ADDENDUM NO. 04
DATE: May 7, 2020
PROJECT: Inglemoor High School Concert Hall + Music Building Project

SHEET TL8.2 – Theater Lighting - Schedules

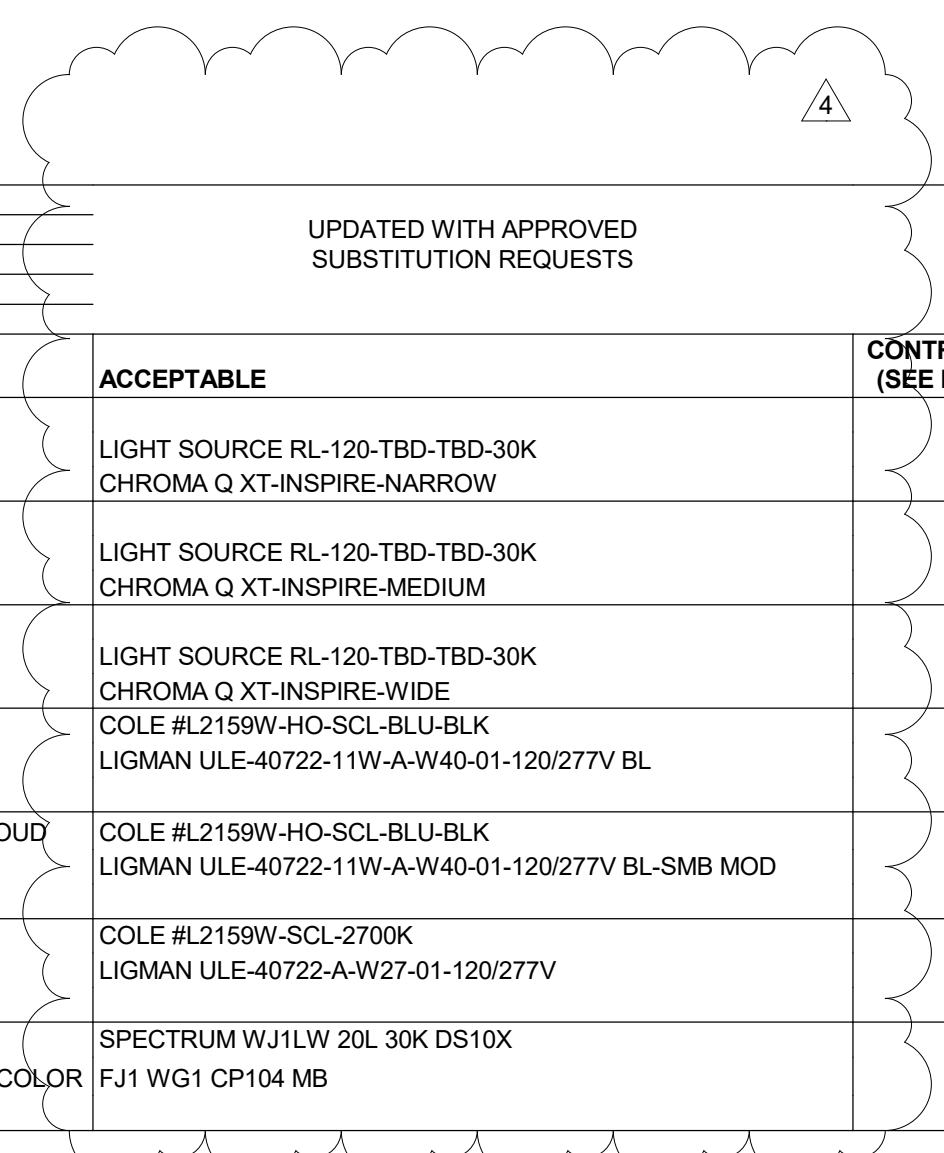
1. REVISE House Lighting Fixture Schedule per attachment TL8.2
